City of Portland, Maine – Building or Use Permit Application 389 Congress Street, 04101, Tel: (207) 874-8703, FAX: 874-8716

CITY OF PORTLAND, MAINE
SITE PLAN REVIEW (ADDENDUM)
CONDITIONS OF APPROVAL

RE: 56 Shepherd Lane
Portland, Maine

REASON FOR PERMIT: To construct a single family dwelling

First Floor Plan

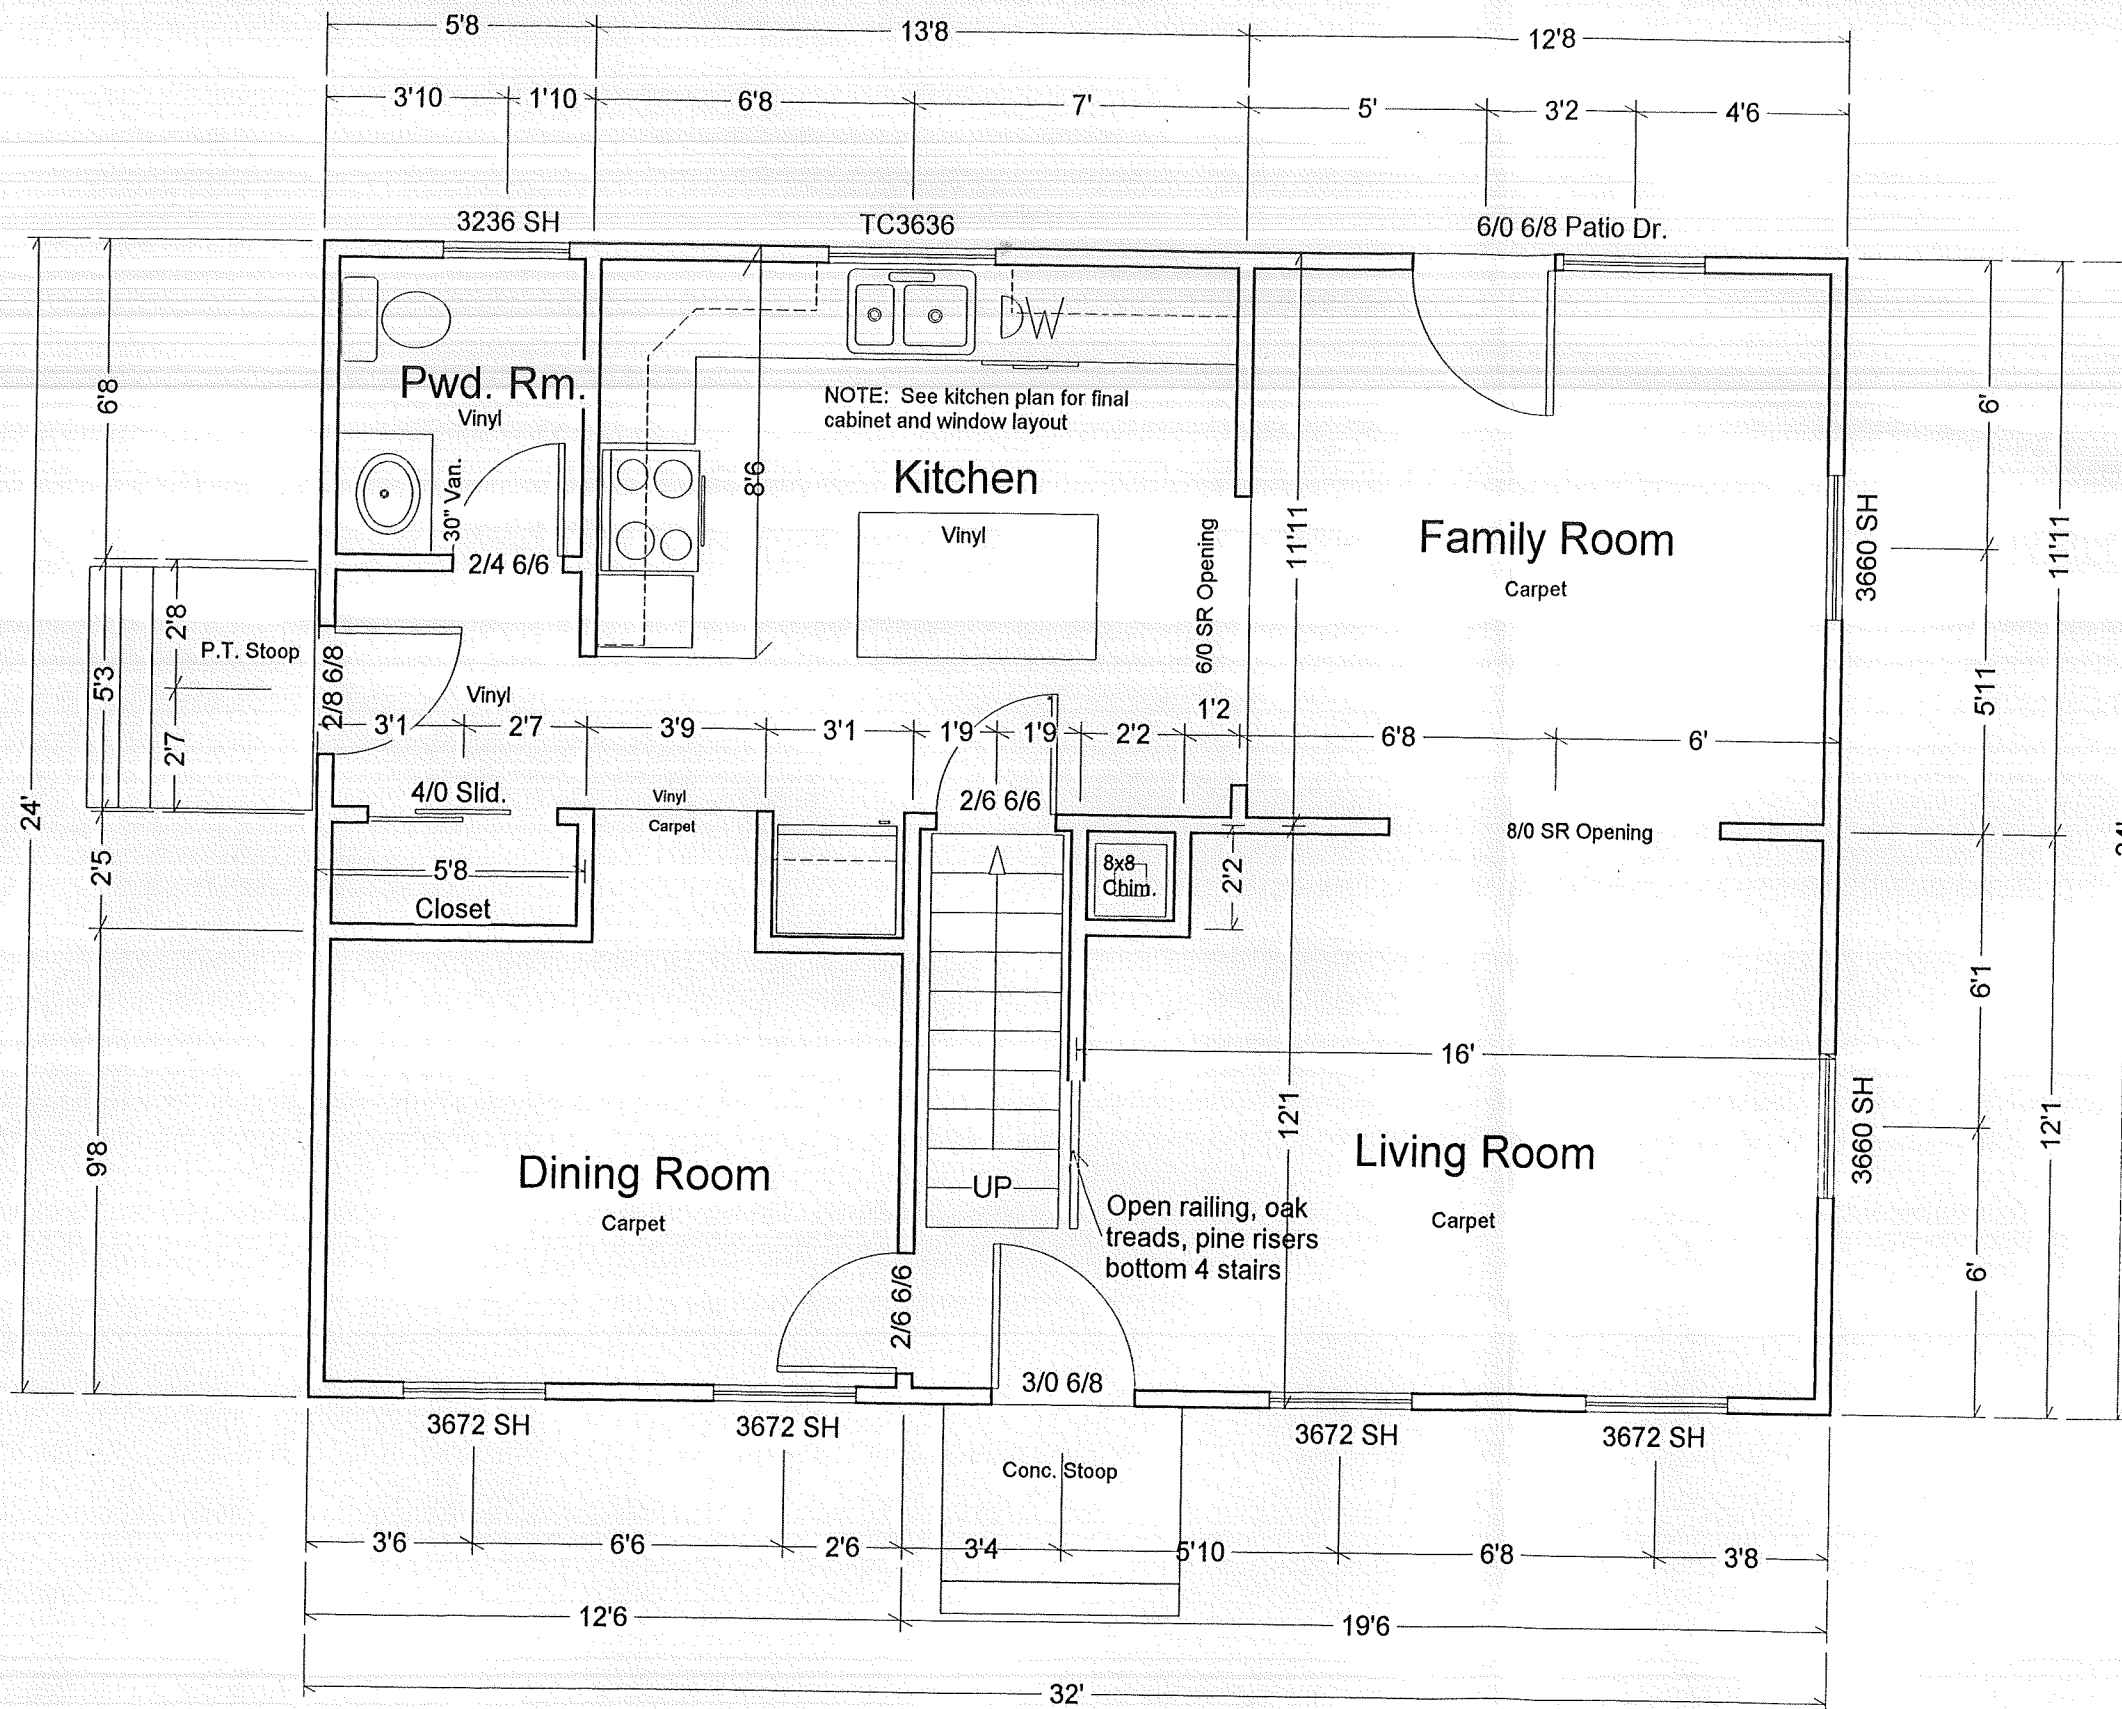
- 1-11-95 8" Foundation (24'x32') w/ rear bulk head / Setbacks appear OK
- 1-18-95 Foundation capped
- 2-8-96 - Framing OK
- 2-12-96 - Heating permit needed
- 2-16-96 - 1st fl joist 2x8 16" oc plans state 2x10 16" oc (12' span)
all other framing OK per plans (carry beam bracket notched @ each end 2" depth)
- 2-26-96 - Work in progress
- 2-27-96 - Side stairs needs sm. tubes / rear stairs temp. type / side walk covering @ sewer hook up.
- 3-13-96 CAO Insp. (Bulkhead / weather stripping) 1 Rm 2nd Floor unfinished
sm. tubes / stairs / temp stairs on front to be replaced by (Granite) Done
Rear slider has temp stairs / must. Replace Done
